### **Remarks/Arguments**

Appl. No. 10/656,080  
Amdt. Dated Sept. 9, 2005  
Reply to Office Action of May 9, 2005

Fig. 3A

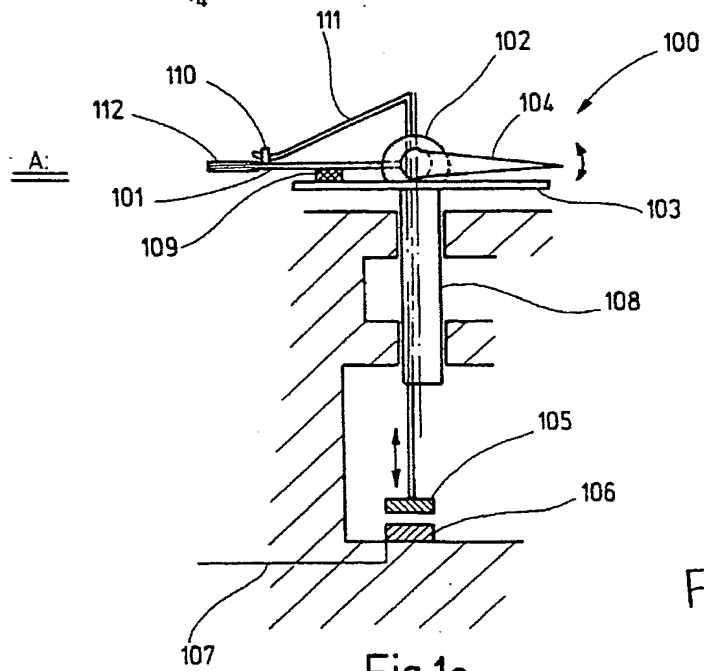
The drawings are amended to renumber the figures and to provide a separate figure number for each drawing. The reference numbers on FIGS. 3A and 6A are changed to be consistent between the drawings and with the specification, and reference indicators that are not mentioned in the description are removed from the drawings.
